ADDENDUM NO. 2

July 29, 2026

The Solanco Area School District | New District Administration Offices & Turf Fields
CRA Project No. 3706

CRABTREE ROHRBAUGH & ASSOCIATES - ARCHITECTS

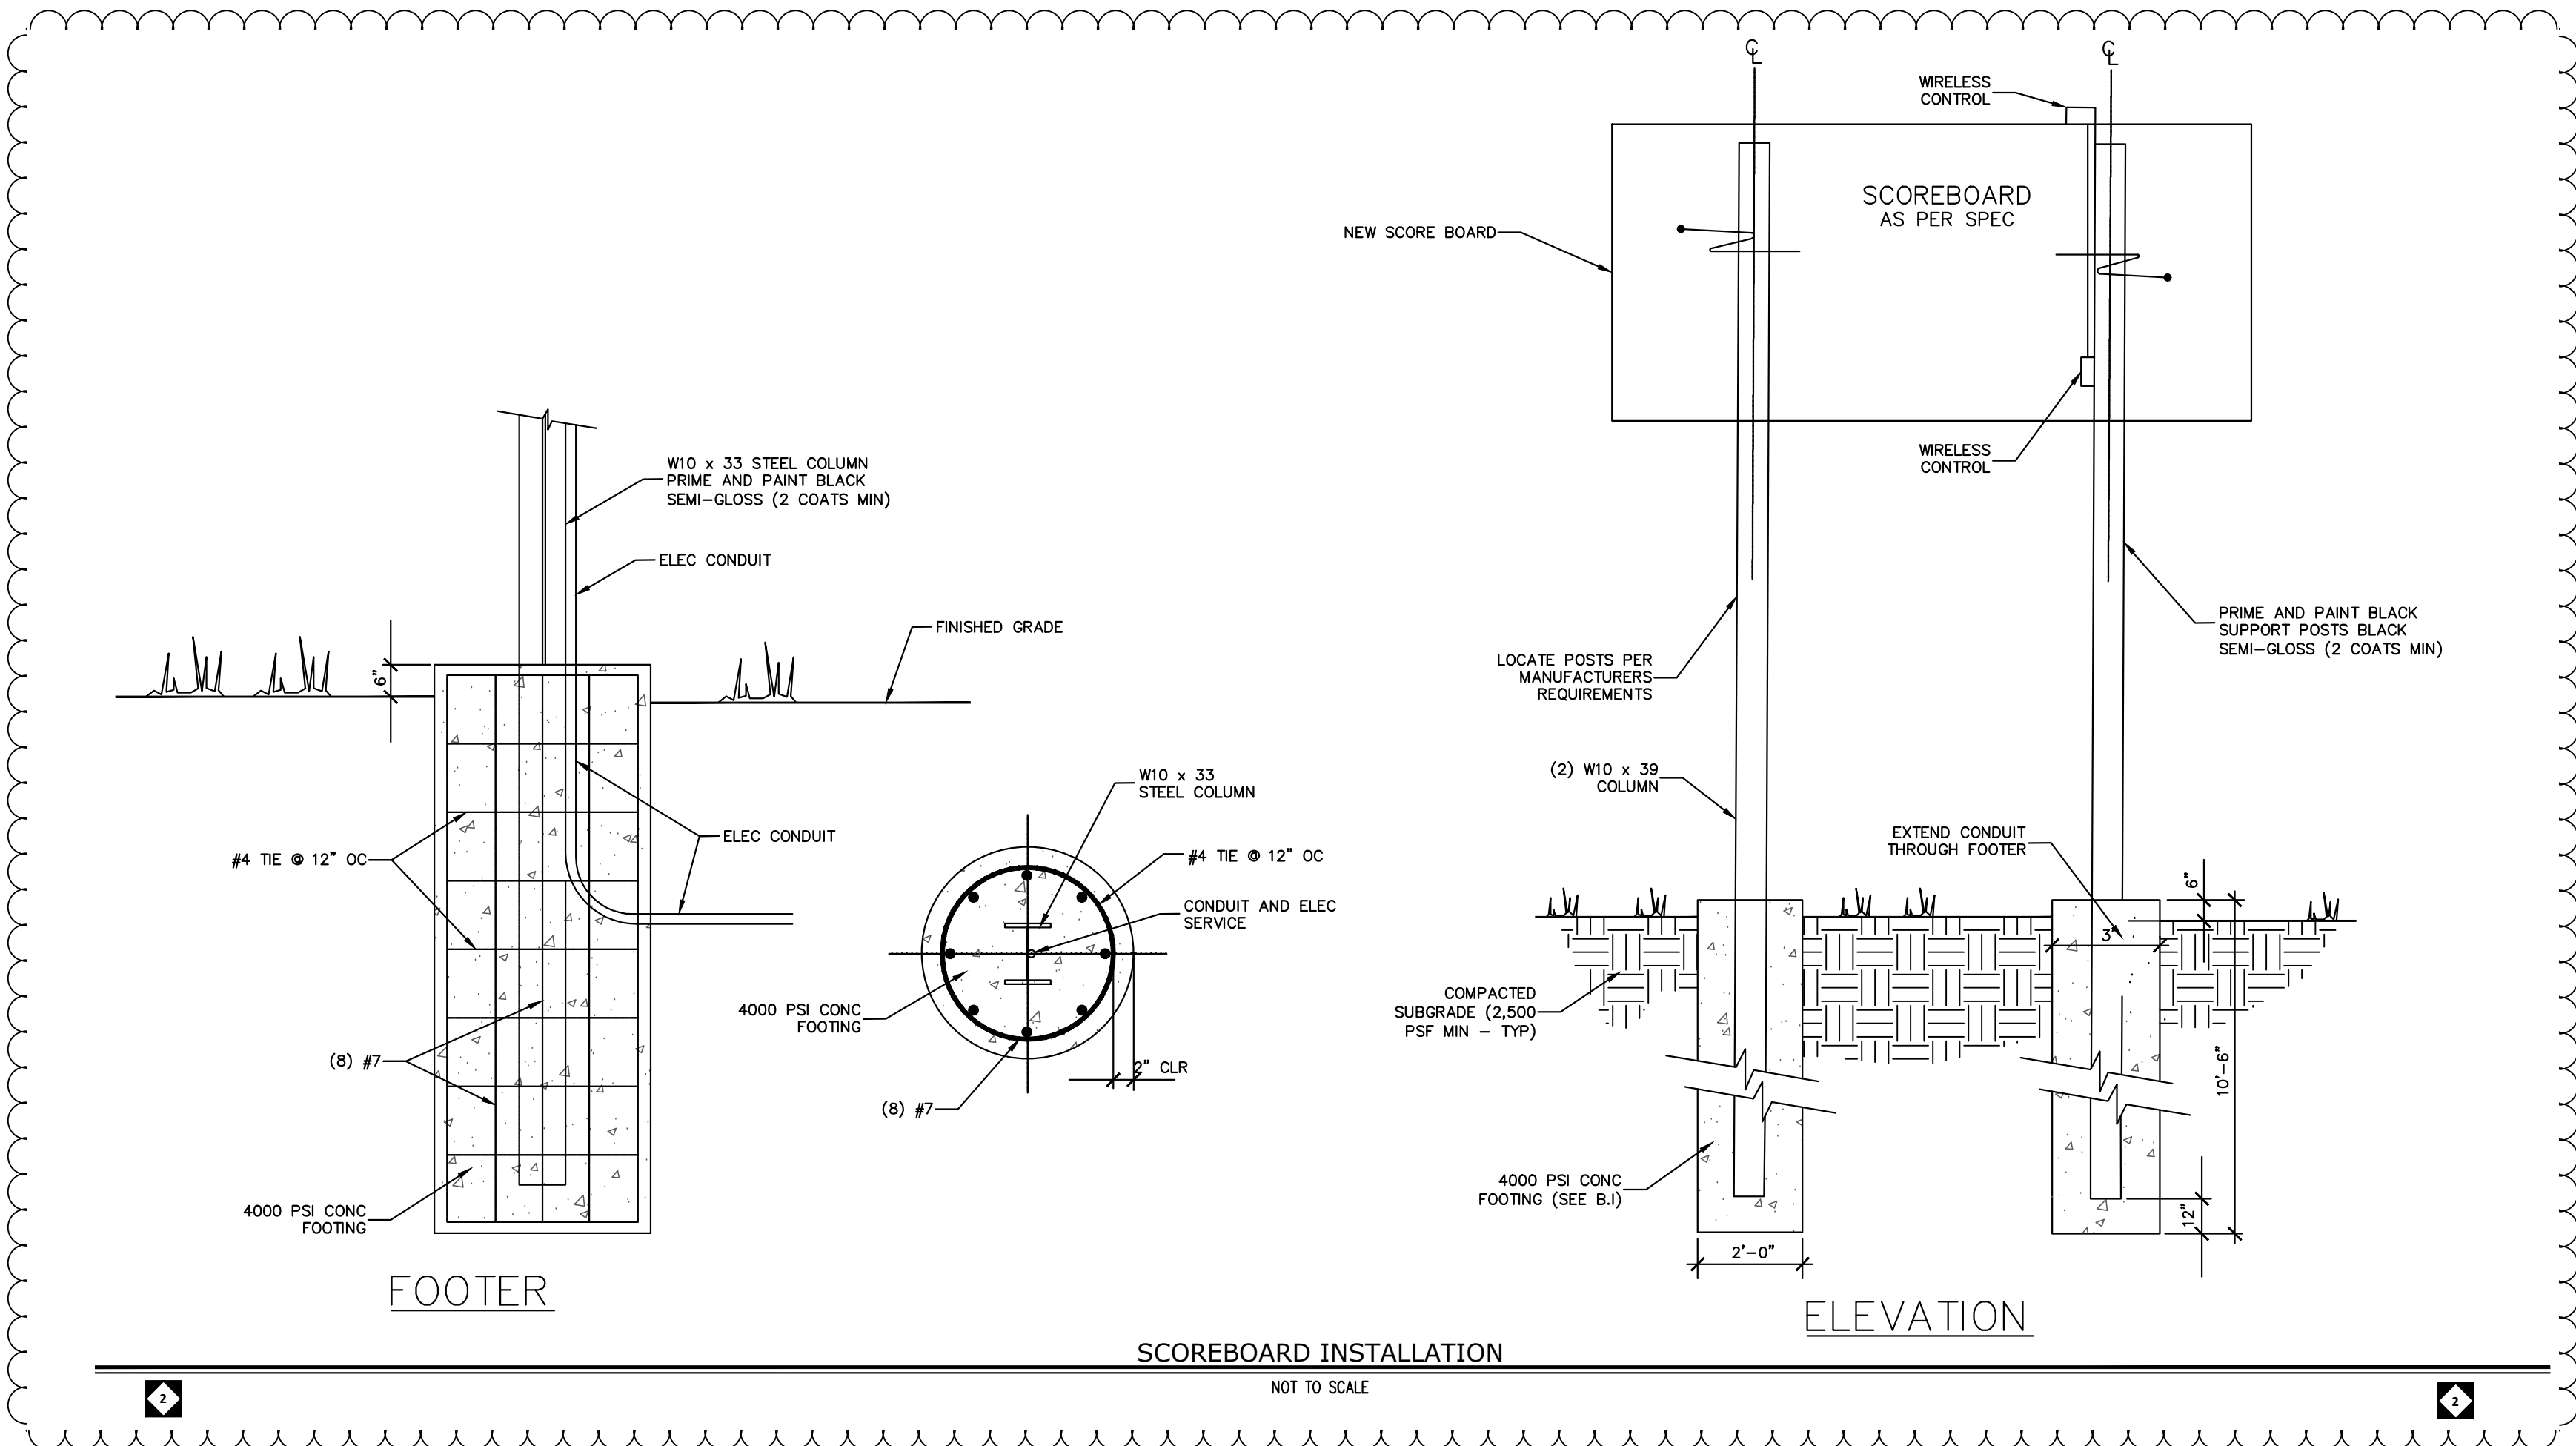
DRAWING C-604– DETAILS

1. **REVISED** the detail name to “PERIMETER TURF CURB WITH INTEGRAL FENCE”.

C605

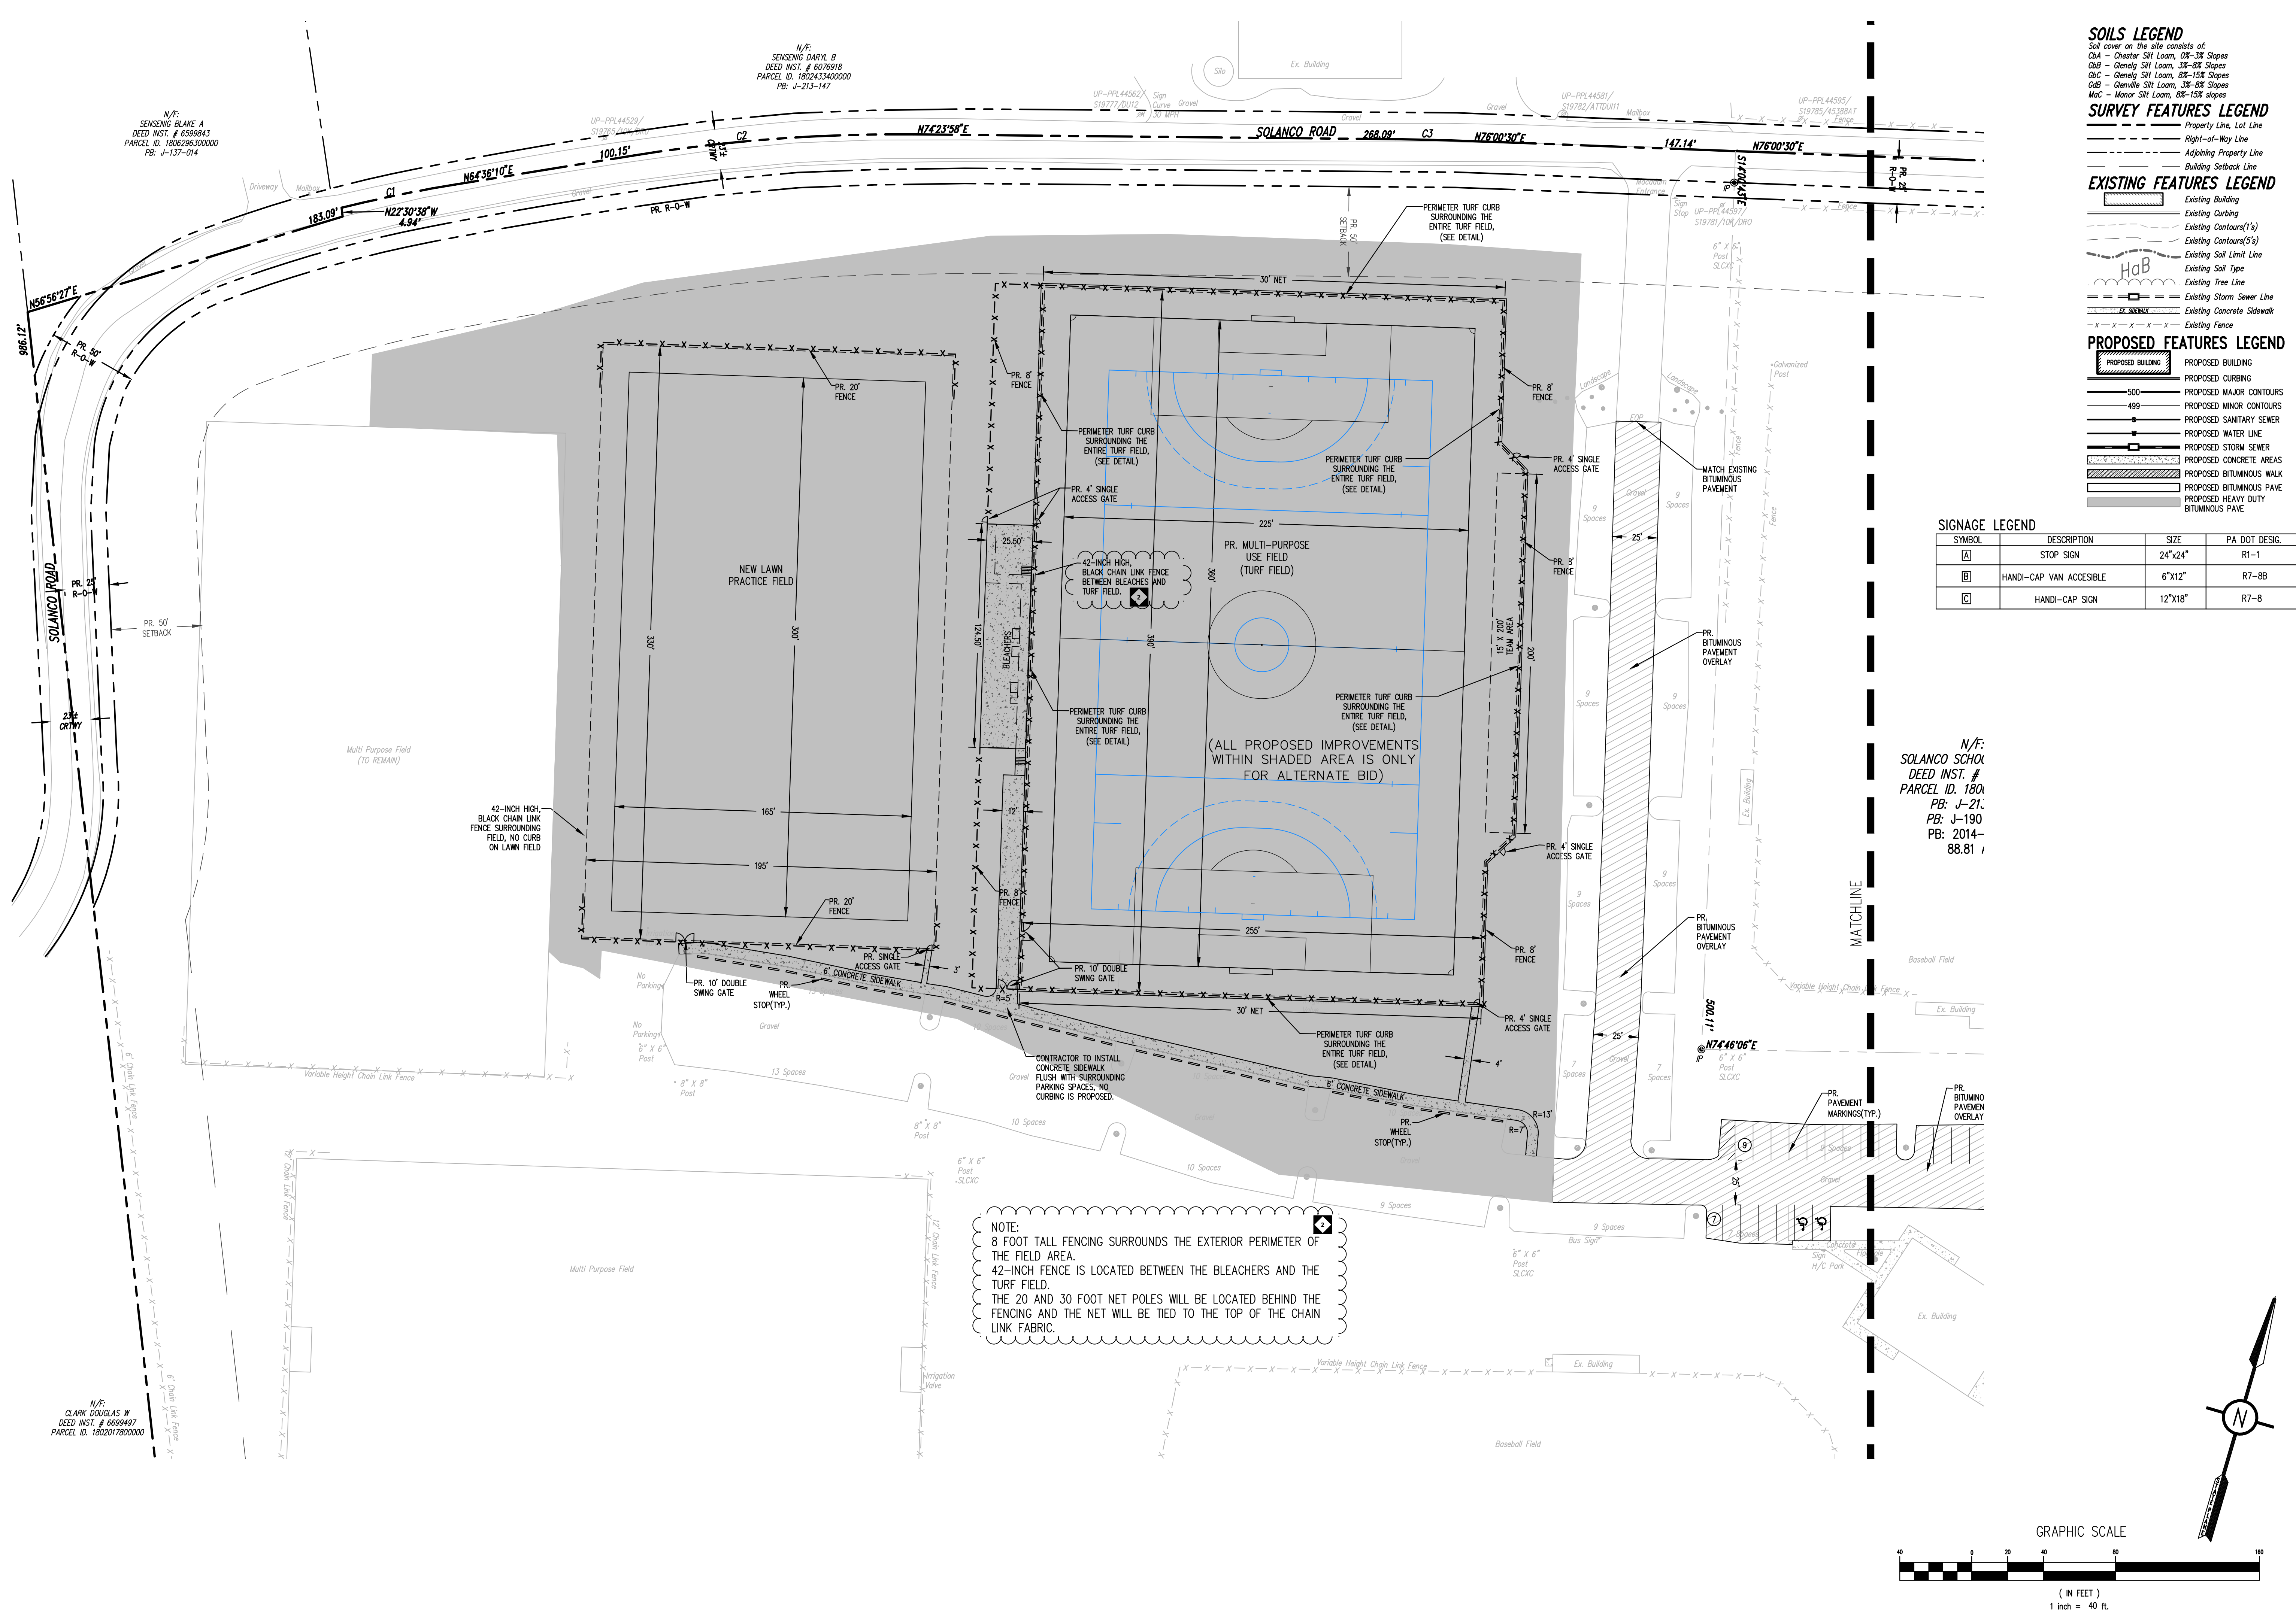
DRAWING C-605 – DETAILS

1. **REVISED** the Scoreboard detail.
2. **REVISED** the Chain Link Fence detail.
3. **REVISED** the Chain Link Fence Gate detail.
4. **ADDED** the Cantilever Gate detail.

PROJECT
3706
C201

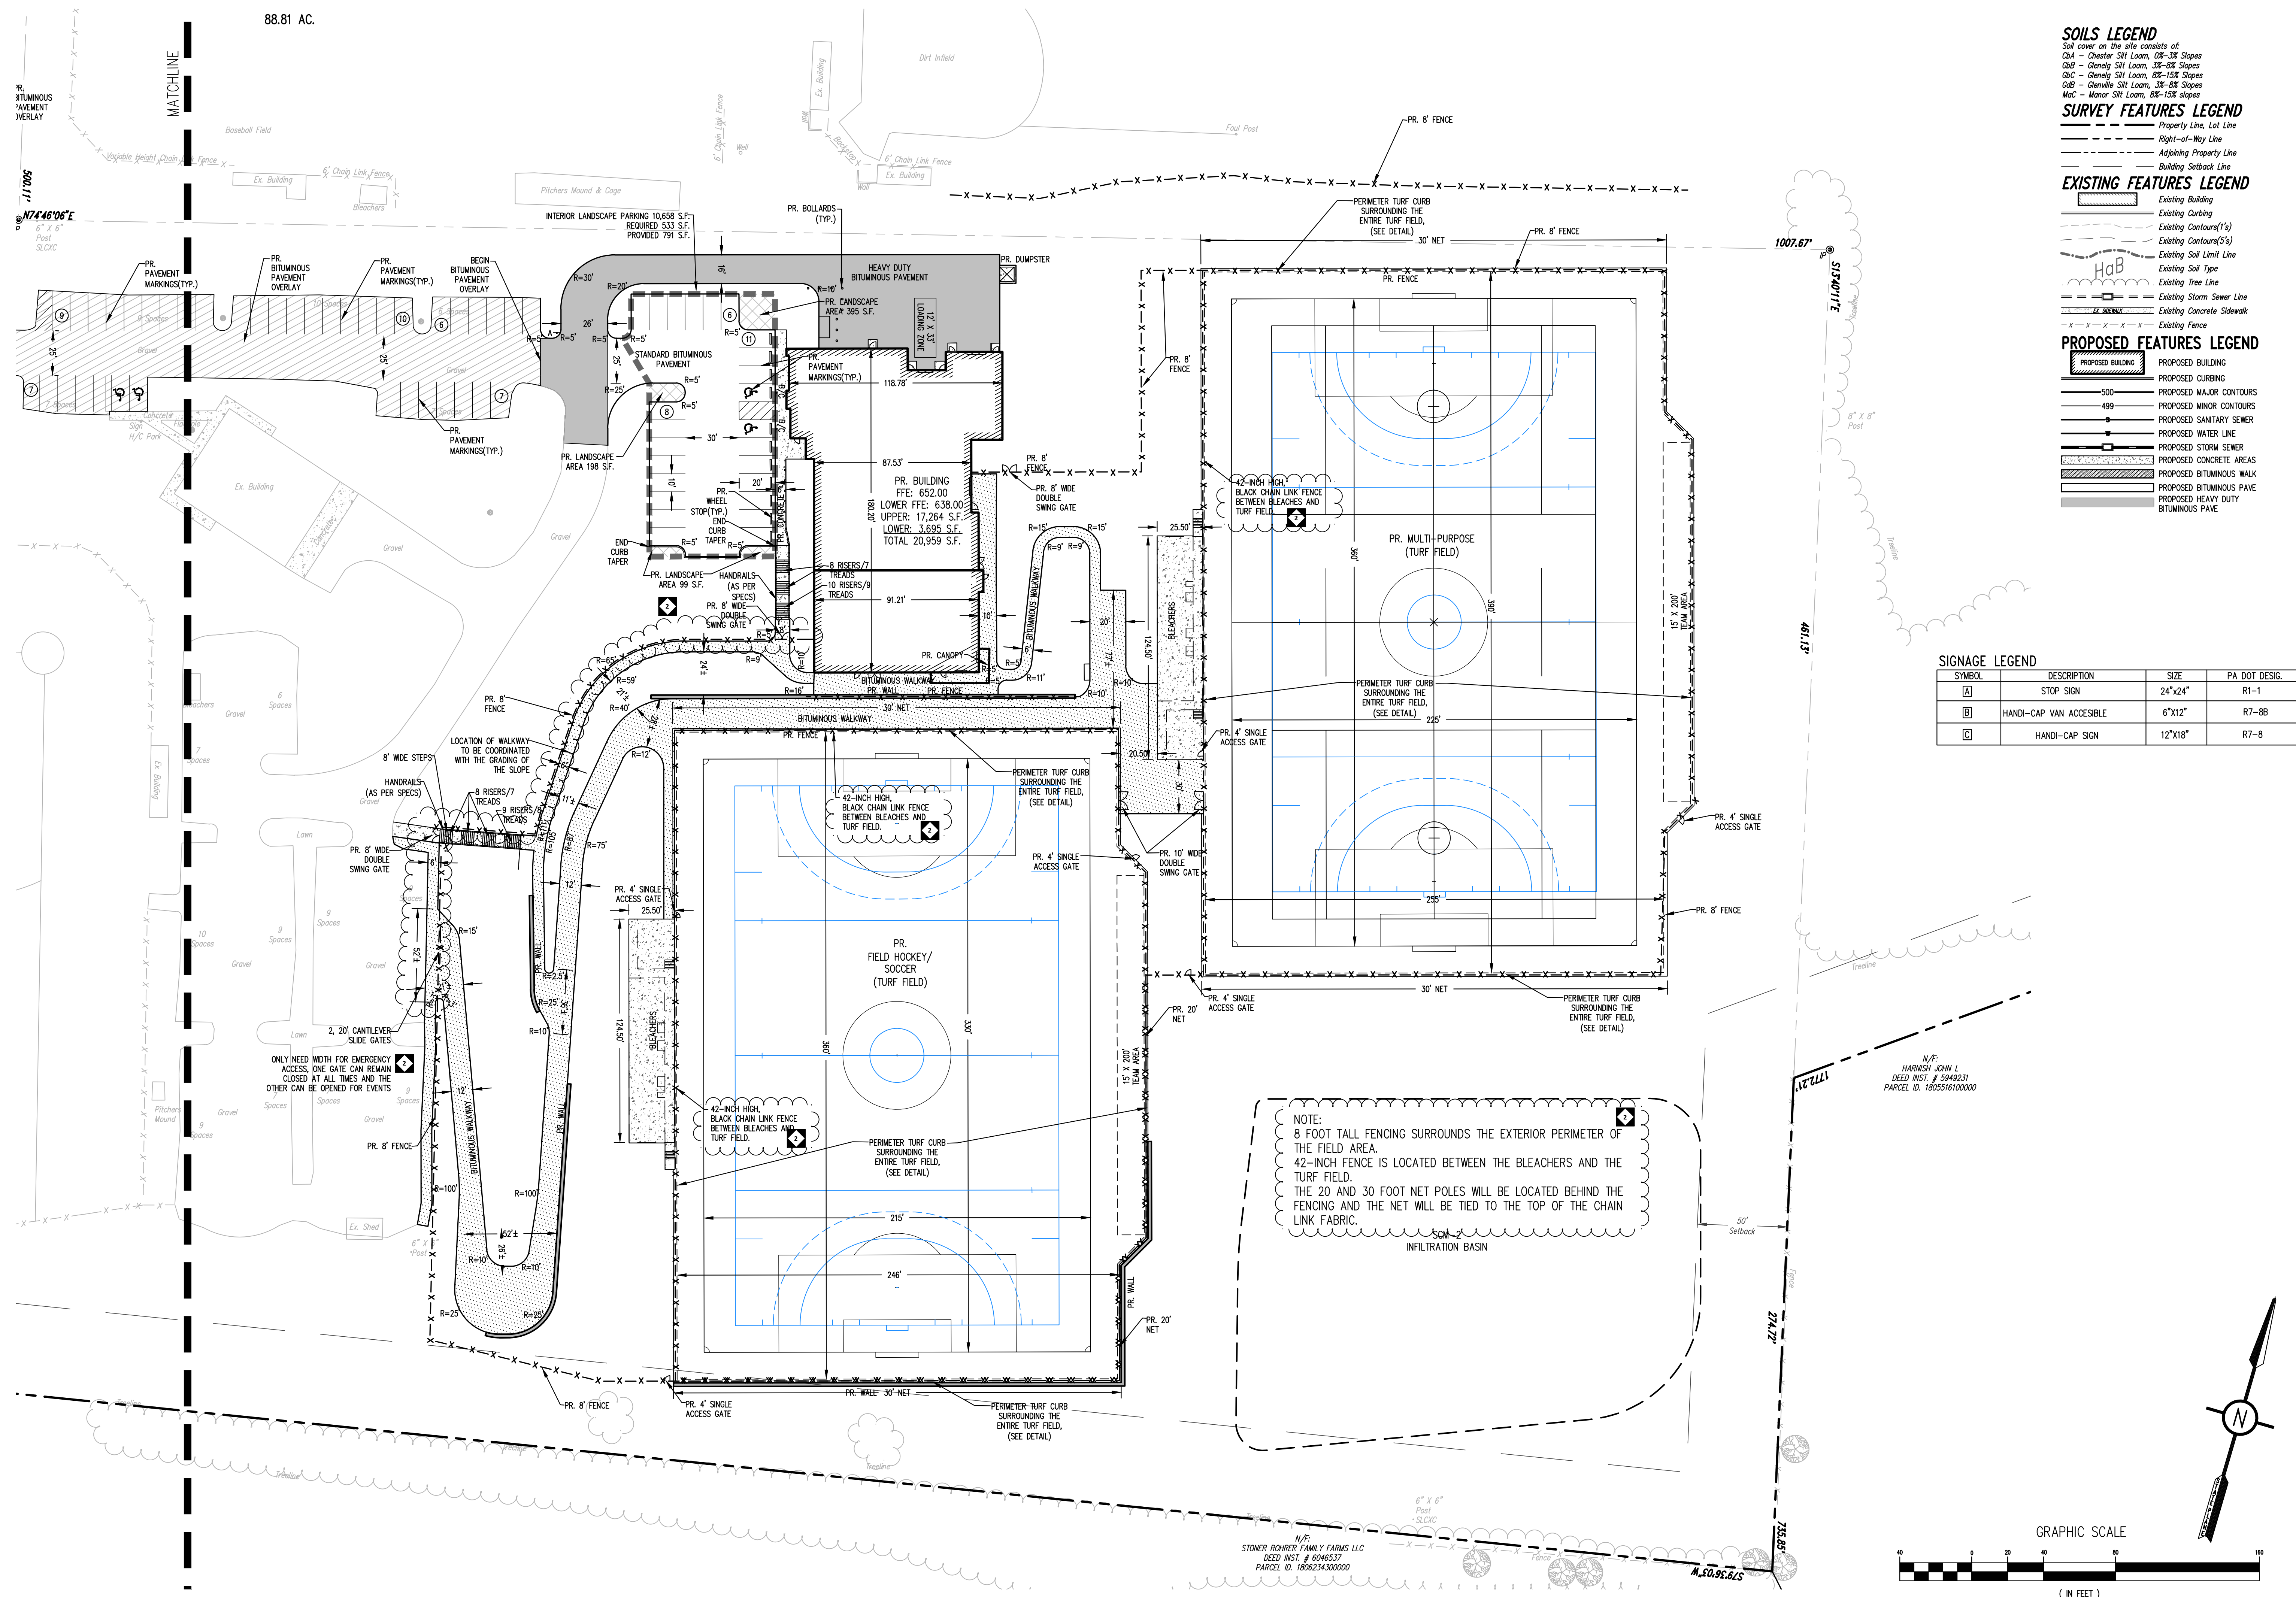
DRAWING C-201-LAYOUT PLAN

1. **REVISED** the fencing labels and added clarification notes.
2. **ADDED** additional fencing and cantilever gates.
3. **REVISED** the Perimeter Turf Curb label.
